**Subject: Response to Administratively Incomplete Determination Part A and General Part B of the Resource Conservation and Recovery Act (RCRA) Permit Renewal Application Los Alamos National Laboratory EPA ID#NM0890010515, HWB-LANL-20-001**

**Response to Administratively Incomplete  
Determination Part A and General Part B of the  
RCRA Permit Renewal Application Los Alamos  
National Laboratory EPA ID#NM0890010515,  
HWB-LANL-20-001**

Below, each numbered NMED-HWB determination is presented verbatim with the Permittees' response following each determination. There are nine attachments to this response document. Attachment 1 includes a crosswalk of the NMED-HWB Determinations and the location of the Permittees' response as well as a summary of the changes for ease in review. Attachment 2 includes maps of groundwater contamination plumes at LANL. Attachment 3 includes seismic information to demonstrate compliance with facility locations standards for each of the three proposed permitted unit locations. Attachment 4 consists of a redline version of the Permit Renewal Application text for Sections 1-7 including a new certification page signed by all Permittees in Section 8. Attachme

## Ground Water Elevation Contour and Approximate Extent of 50 ppb Chromium Plume Map, Mortandad Canyon, CY 2020, Quarter 4

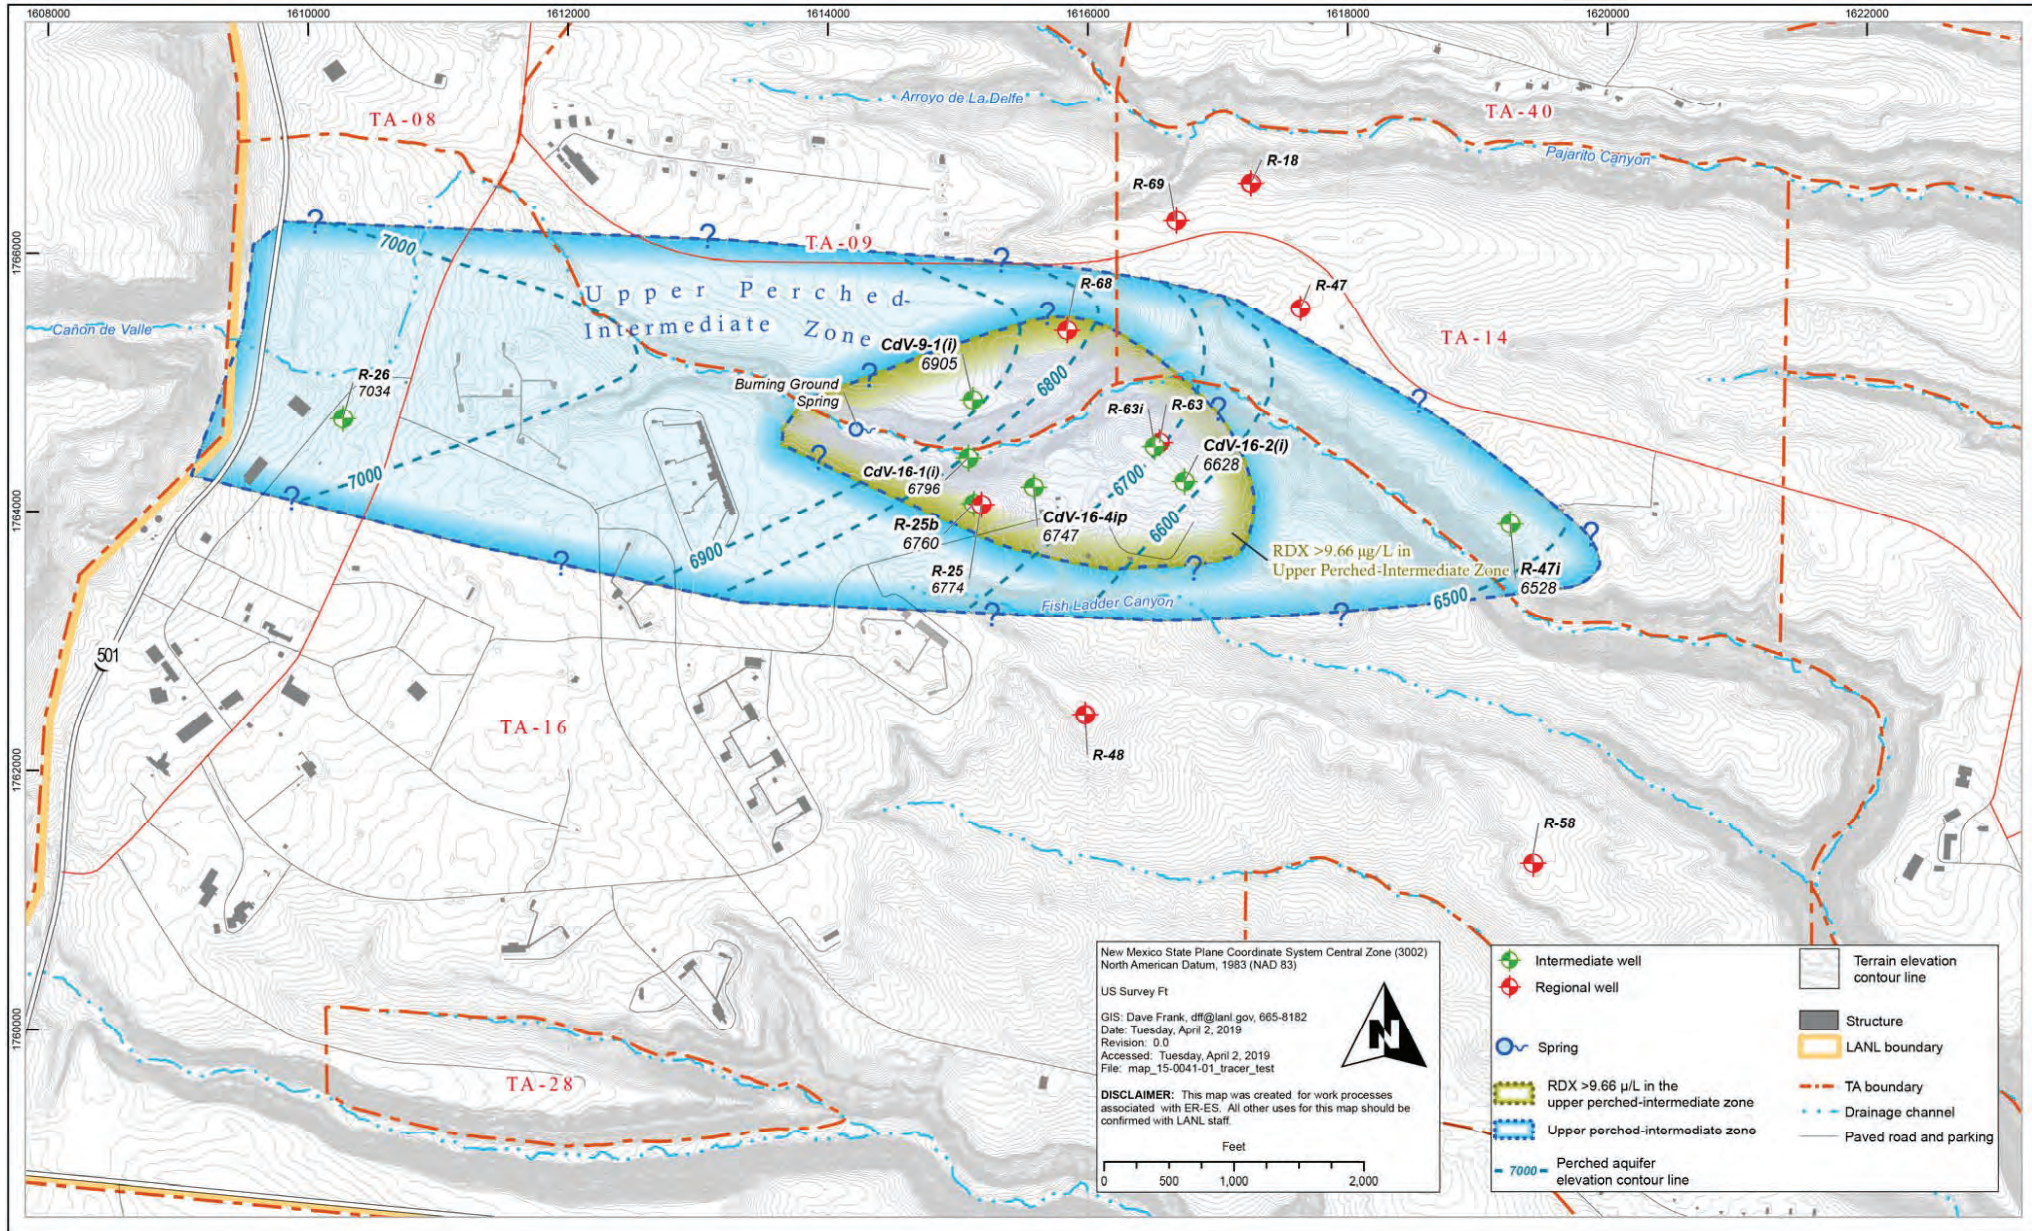
The United States Department of Energy (DOE), Newport Nuclear-BWXT (N3B), and Triad National Security, LLC. (Triad), collectively the Permittees, have not provided maps depicting the extent of the existing ground water plumes at the LANL Facility (Facility, as defined in 40 CFR 260.10) in accordance with the above requirements. Maps 2 and 3 show National Pollution Discharge Elimination System (NPDES) site locations and other groundwater monitoring wells, however, these maps do not provide contaminant plume boundaries. Include maps depicting extent of plumes and maximum concentration of contaminants on a topographic map as required by 40 CFR 270.14(b)(19).

There is no evidence of groundwater contamination associated with the regulated units at LANL; therefore, a map of groundwater contamination plumes is not included within the Permit and was not included within the Permit Renewal Application. As described in Permit Renewal Application Section 2.16, *Groundwater Monitoring*, groundwater at LANL is monitored under the 2016 Consent Order by the LANL Interim Facility-Wide Groundwater Monitoring Plan. There are no changes proposed to Permit Section 11.3.1, *Groundwater Monitoring* presented in the Permit Renewal Application Section 2.16. All known groundwater plumes are from SWMUs/AOCs, and are addressed under the Consent Order. As a courtesy, the most recent published plume maps for chromium and RDX are attached to this response (Attachment 2). These plume maps have already been provided in the *Quarterly Report for the Discharge of Treated Groundwater to the Regional Aquifer under Discharge Permit 1835, Calendar Year 2020 Quarter 4*, submitted to NMED-HWB February 26, 2021, and *Investigation Report for Royal Demolition Explosive in Deep Groundwater*, submitted to NMED-HWB on August 29, 2019, located in the N3B electronic reading room, <https://ext.em-la.doe.gov/epr/readingroom.aspx?room=2>. It should be noted that concentration/plume maps will change based upon data results.

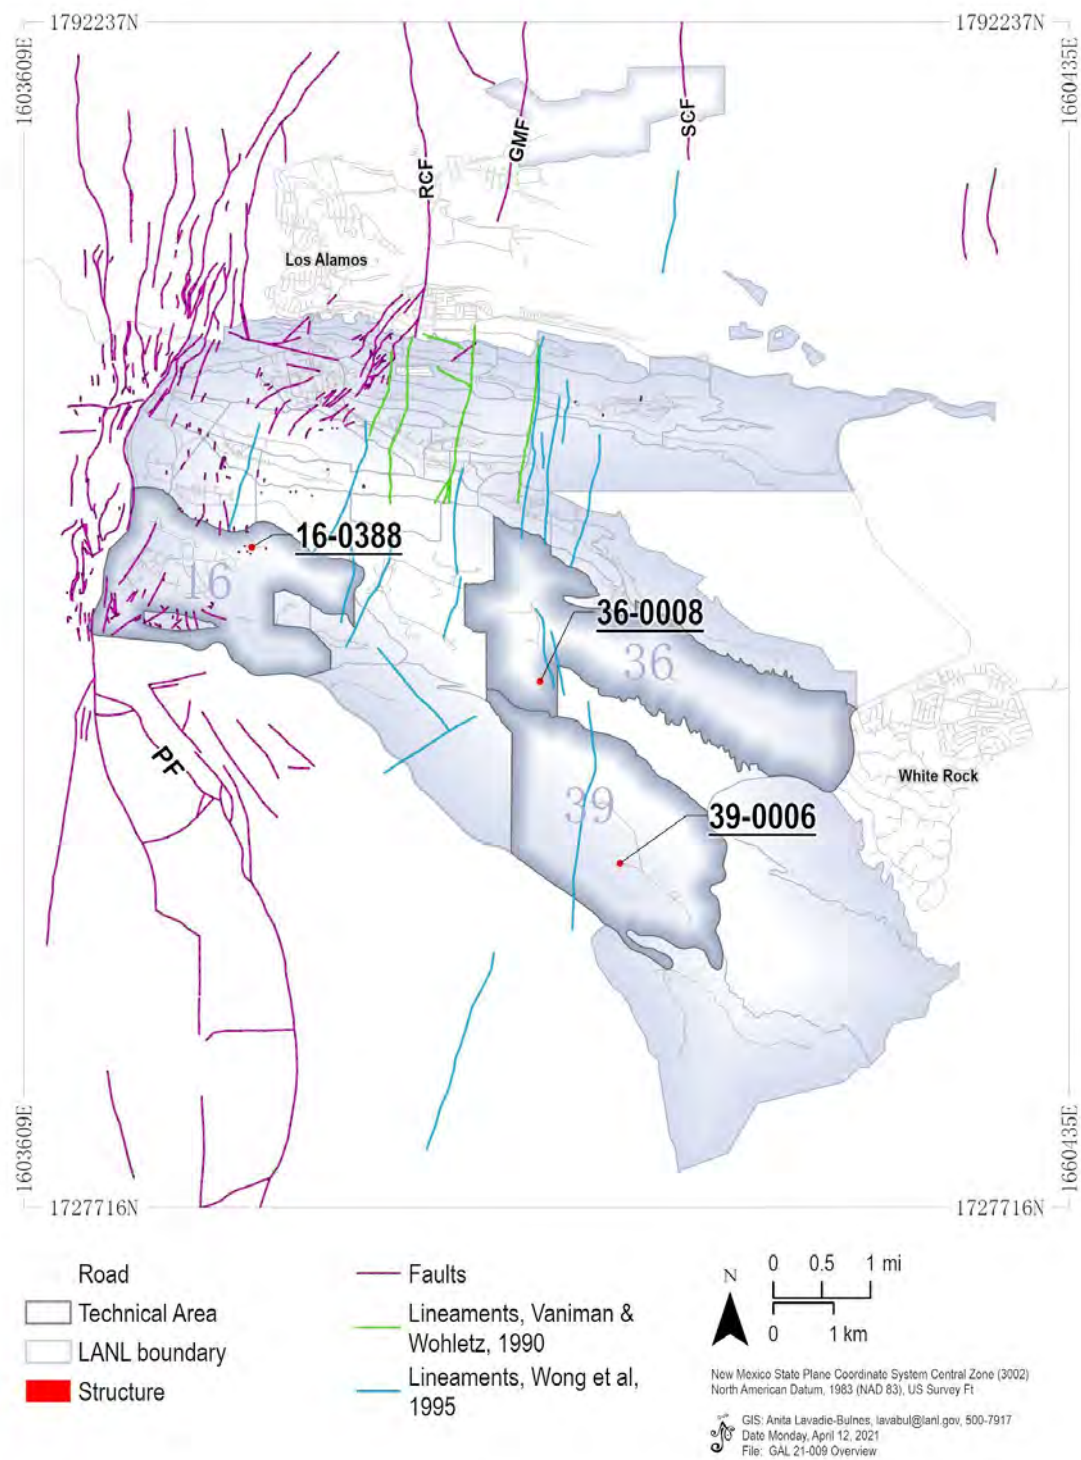
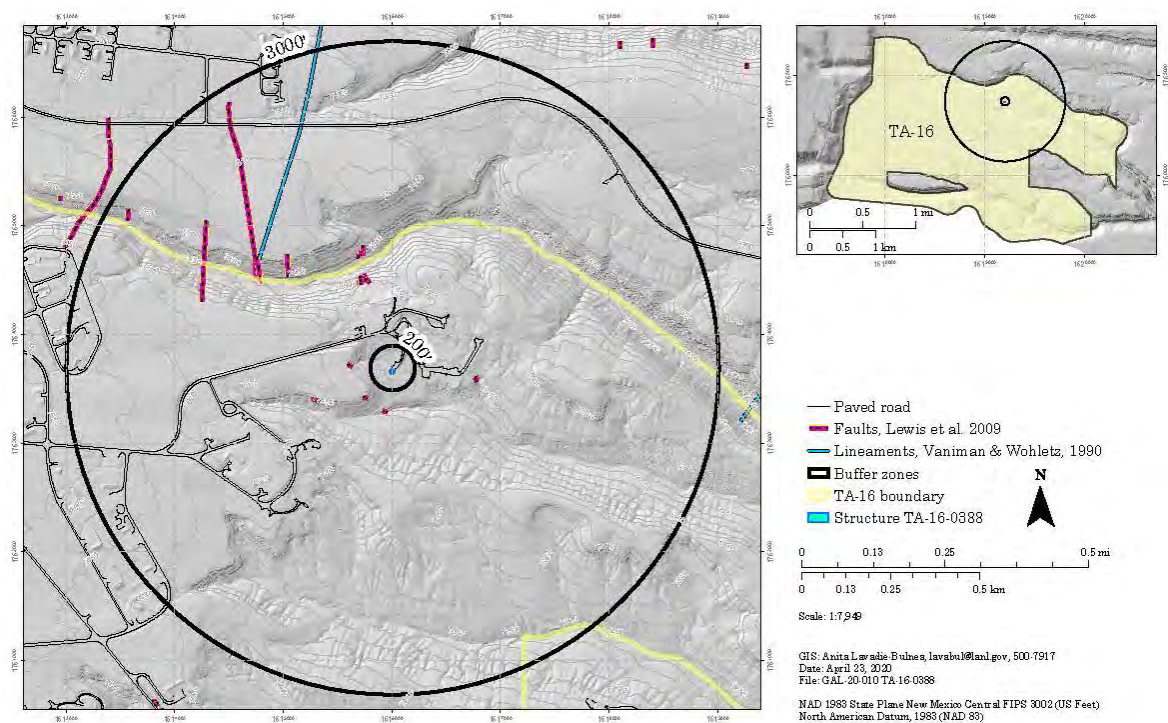
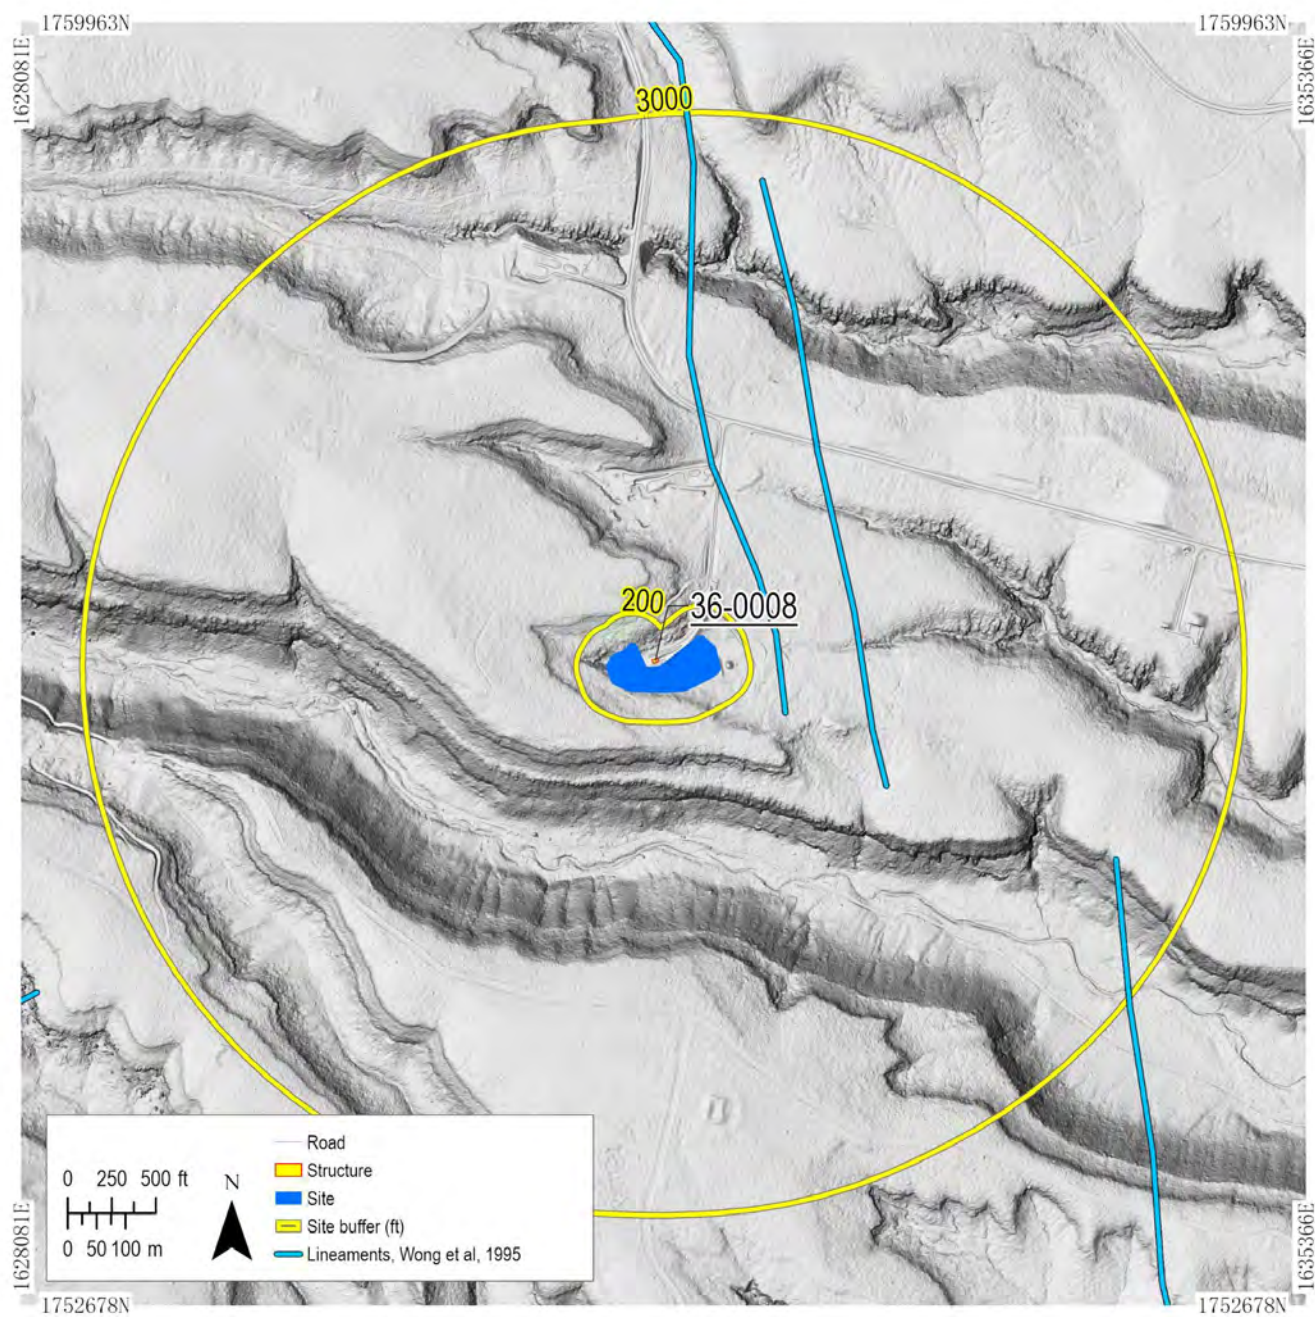
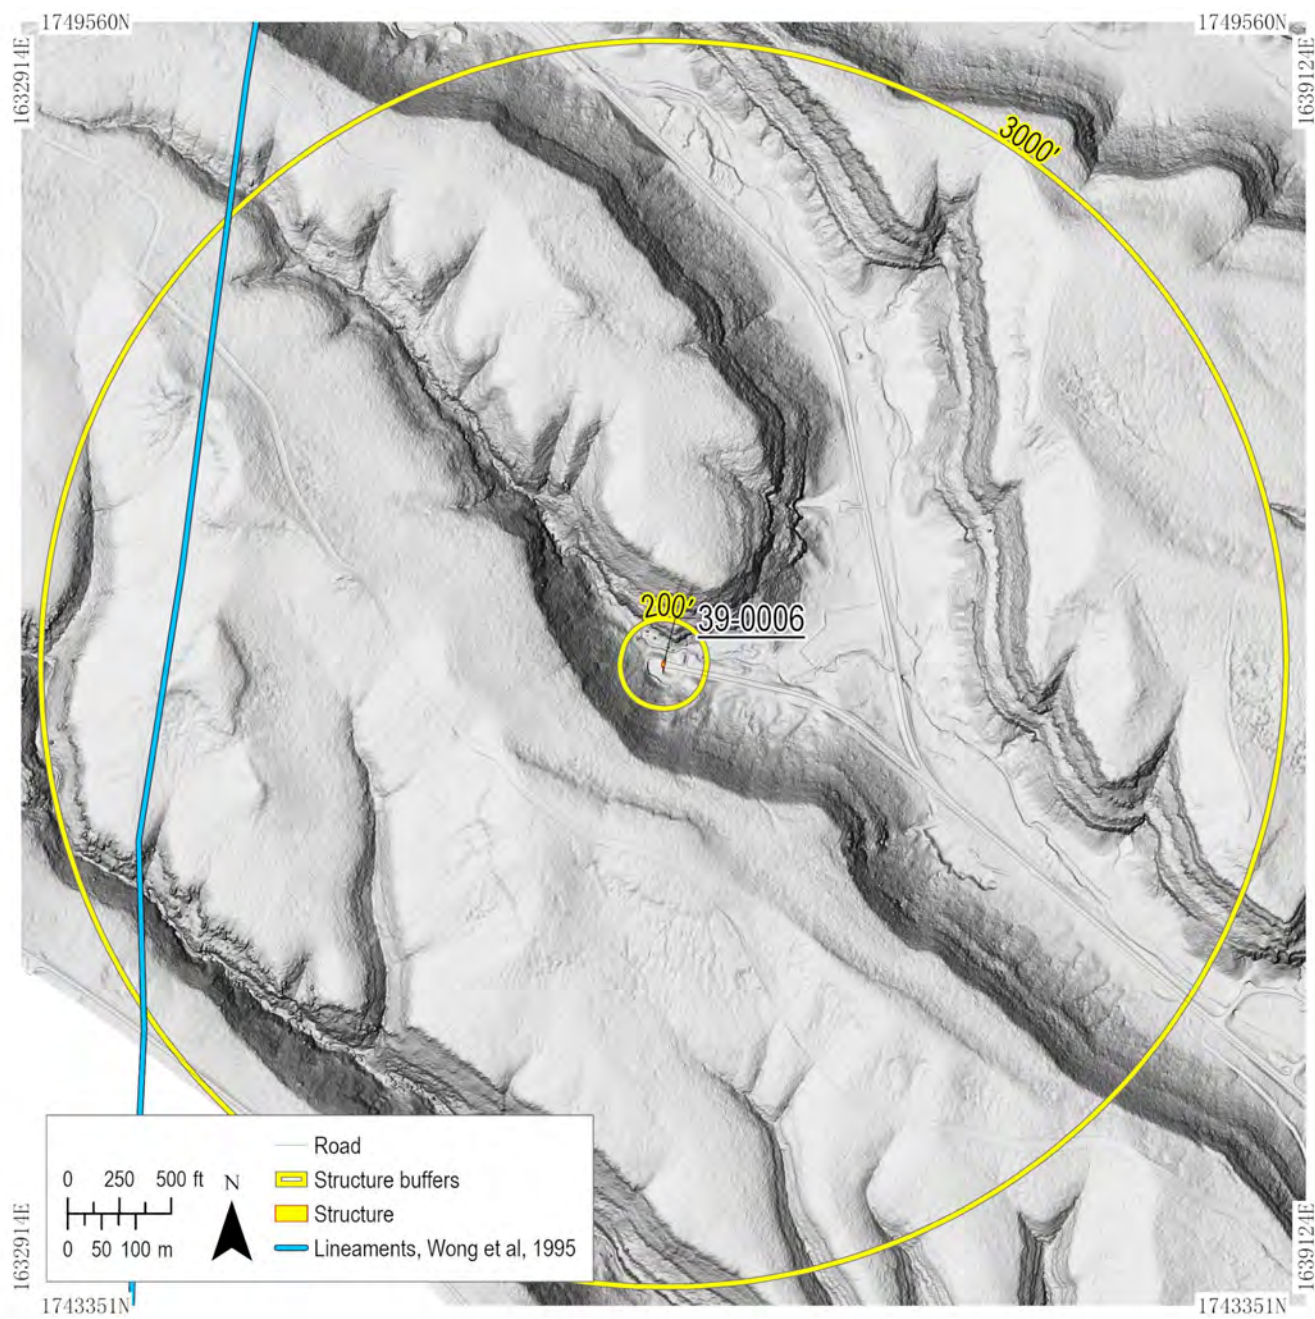
Appendix VI of 40 CFR 264, therefore, the Permittees must provide geologic data which demonstrates compliance with the seismic standard (see 40 CFR 270.14 (b)(11) for more information). The Permittees must provide seismic information for the three (3) waste treatment units proposed to be included in the permit (i.e., Technical Area (TA) 16-388, 36-8, and 39-6).

Attachment 3 includes maps and seismic location information for the proposed open burning and open detonation units at TA-16-388, TA-36-8, and TA-39-6. Text reflecting the addition of the seismic location information is added to the Permit Renewal Application Section 2.10.1, *Seismic Standard* in Attachment 4 of this response. Although the seismic investigation included in Attachment 3 demonstrates that there has been no direct evidence observed for Holocene faulting within the required radius of the facility, it is noted within the seismic report that field reconnaissance may be required to confirm the determination, as field activities are delayed due to COVID 19 safety restrictions.
